ATTACHMENT A

2.0 LIMITING CONDITIONS FOR OPERATION  
2.1 Reactor Coolant System (Continued)  
2.1.2 Heatup and Cooldown Rate (Continued)

## ATTACHMENT B

### JUSTIFICATION, DISCUSSION

FIGURE  
2-1A

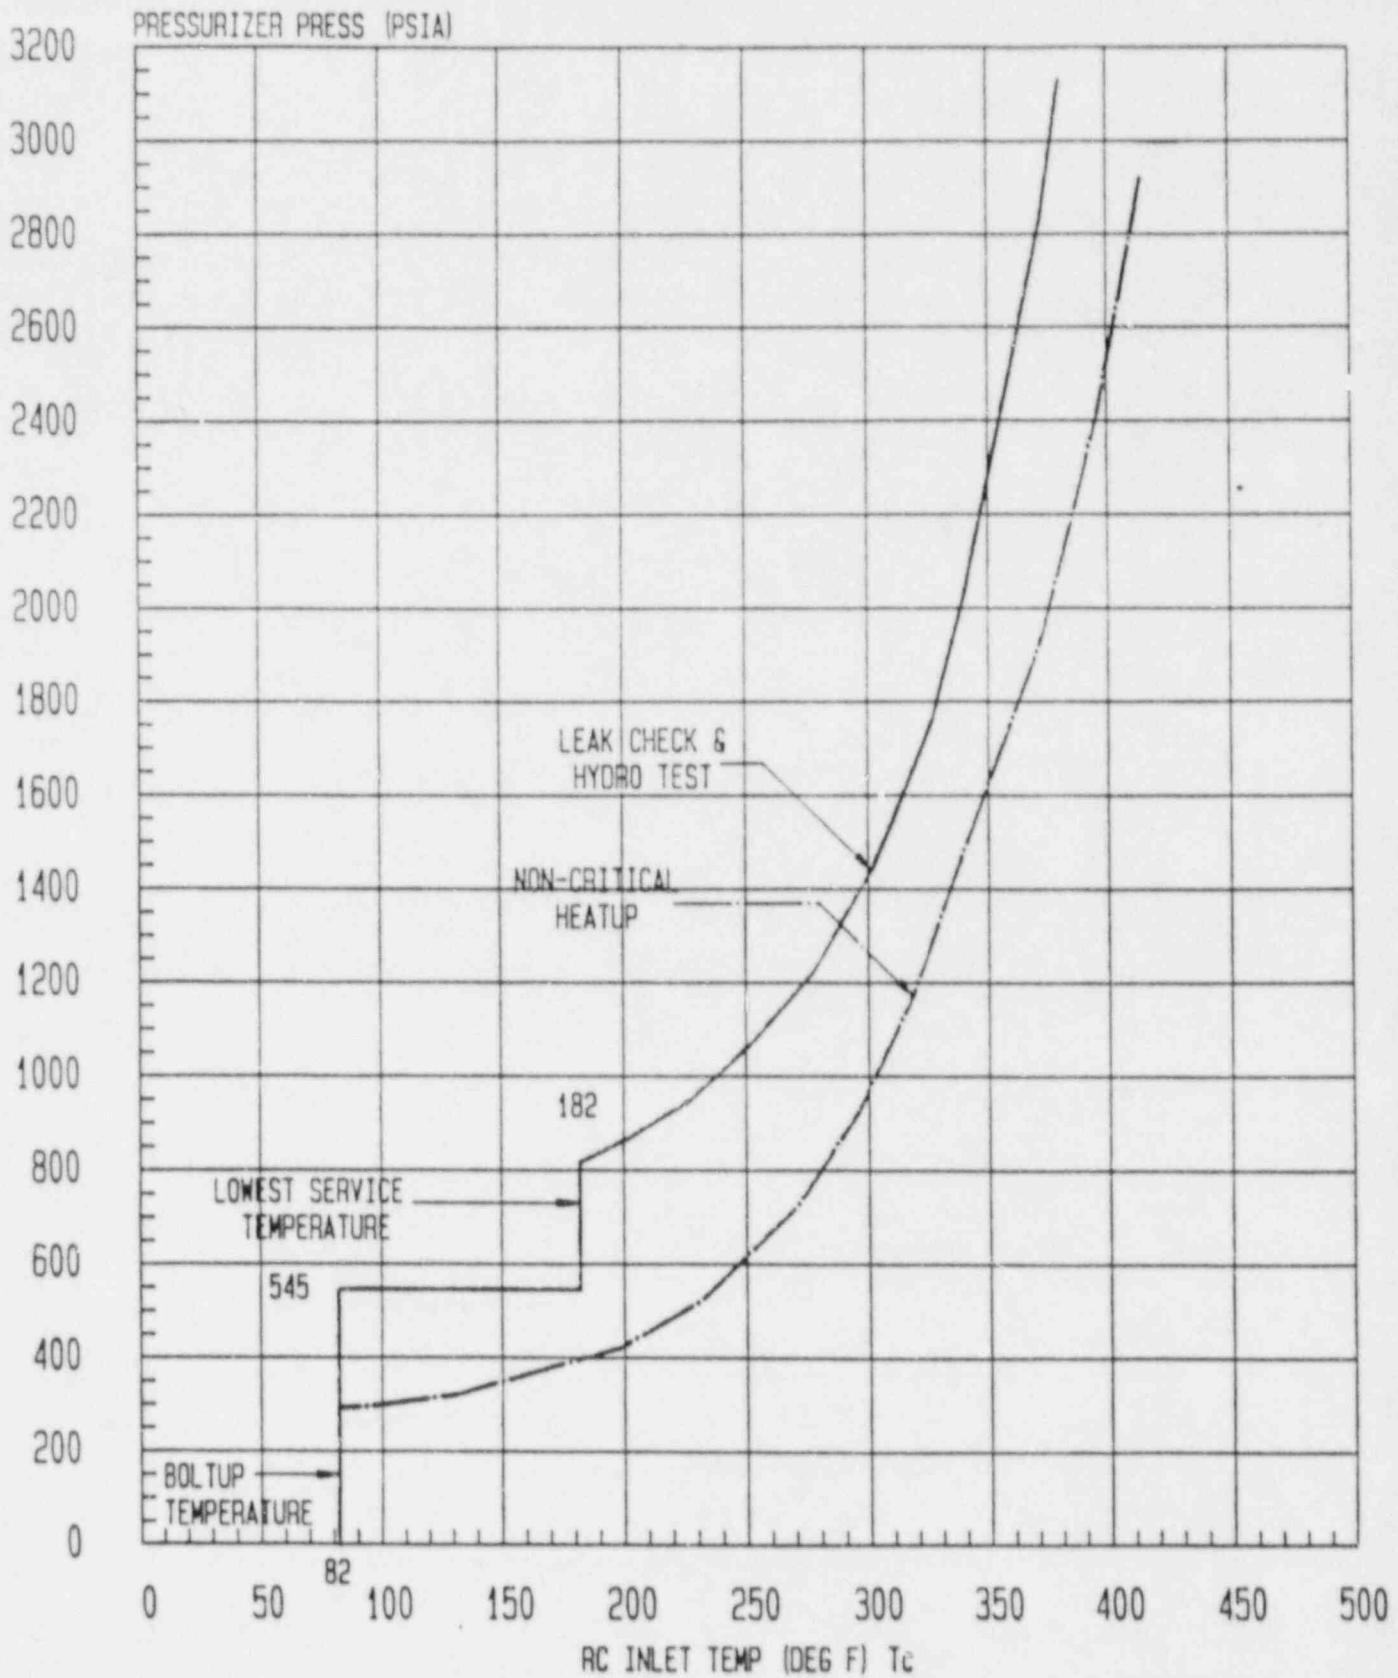
This proposed amendment corrects the labels of the heatup and cooldown curves (Figures 2-1A and 2-1B) from 15.0 to 14.0 EFPY. Figure 2.3 is corrected to reflect the more conservative shift prediction equation associated with the limiting weld wire heat in the lower longitudinal weld seams. The predicted 40 year integrated flux was also revised to be consistent with the fluence prediction equation used in this assessment. Reference to 15.0 EFPY in the Basis Section is revised to 14.0 EFPY and the corresponding change from Cycle 16 to Cycle 15 is also made.

# RCS PRESS-TEMP LIMITS HEATUP

14 EFPY

# PREDICTED RADIATION INDUCED NDTT SHIFT

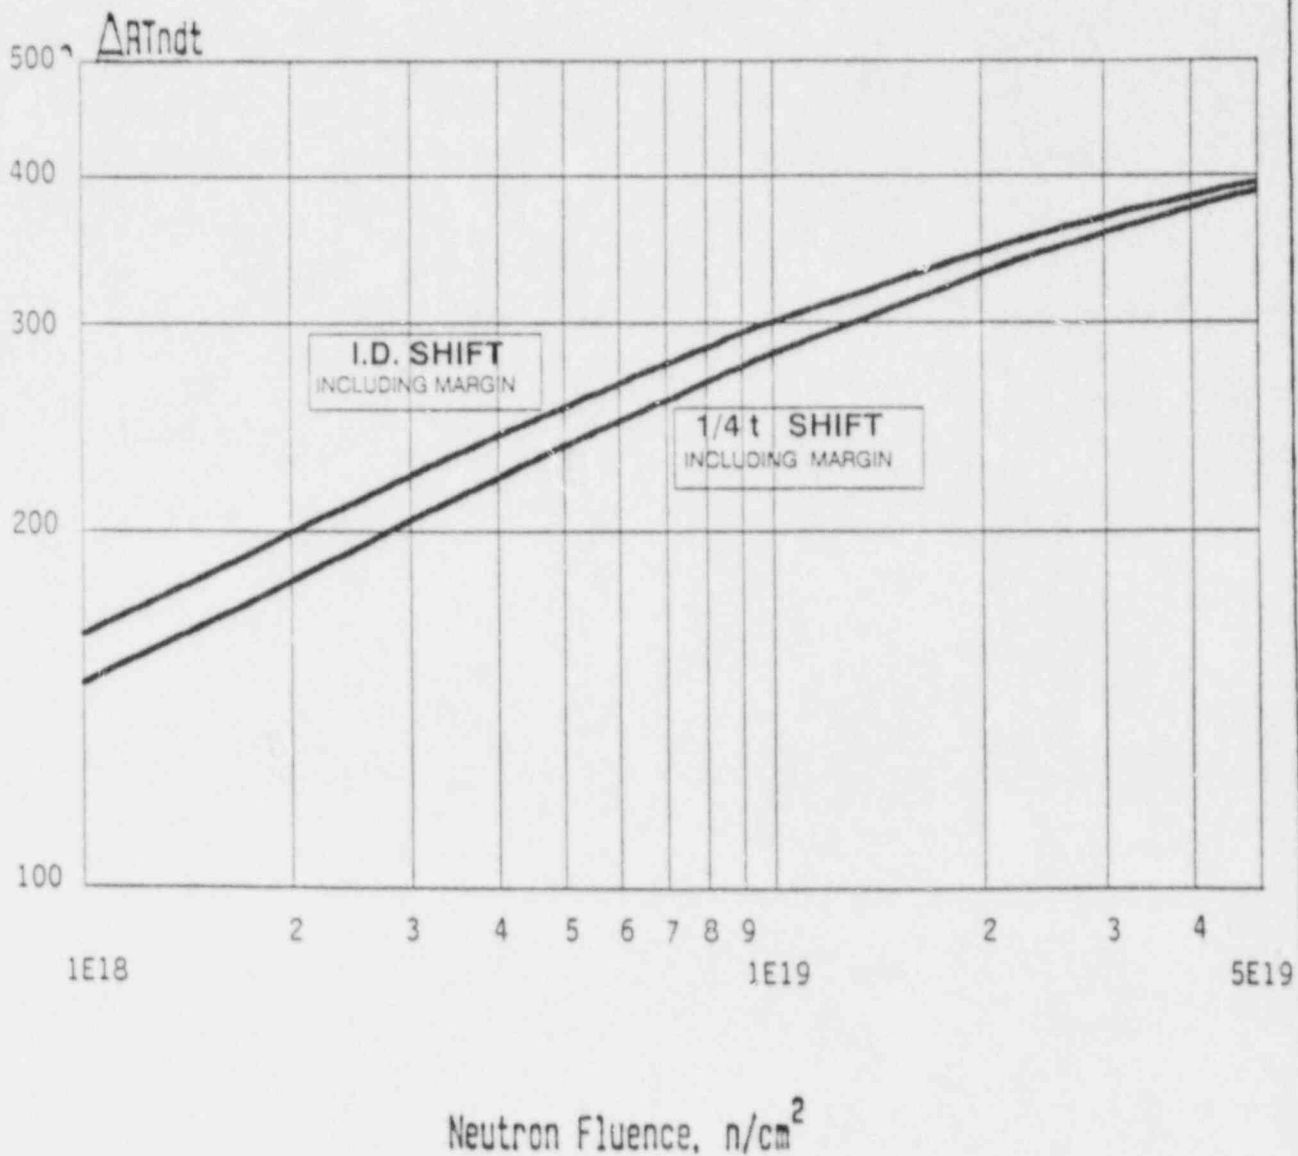
Documentation of the chemical content of all Fort Calhoun reactor vessel belt-line materials was completed in 1986 (Reference 2). The lower shell longitudinal weld seams (3-410), which consist of three different weld wire heats, were found to be limiting as a result of high copper and nickel content. Since the combination of these welds is unknown, the most limiting weld is used in the RT<sub>NDT</sub> analysis. Weld wire heat 12008, flux lot 3774, containing 0.23 w/o Cu and 0.95 w/o Ni was found to be limiting when using the shift prediction equation of 10 CFR 50.61. This weld was also assumed for use with Reg. Guide 1.99, Draft Rev. 2, when preparing the facility license change to update the heatup and cooldown limit curves to 15.0 EFPY (Reference 3). Further investigation revealed that weld wire heat 27204, flux lot 3774, with 0.22 w/o Cu and 1.02 w/o Ni is more limiting when using the Draft Reg. Guide methodology. Using the chemistry factor associated with this weld wire heat in the Reg. Guide 1.99, Draft Rev. 2 equation demonstrates that the existing Technical Specification heatup and cooldown limit curves (Reference 4) are non-conservative.

The valid lifetime of the existing 15.0 EFPY curves has been reanalyzed using the fluence prediction equation developed in Reference 5 and the more limiting chemistry factor associated with the 3-410 weld seams. The Reference 5 fluence prediction equation for the longitudinal 3-410 weld is:
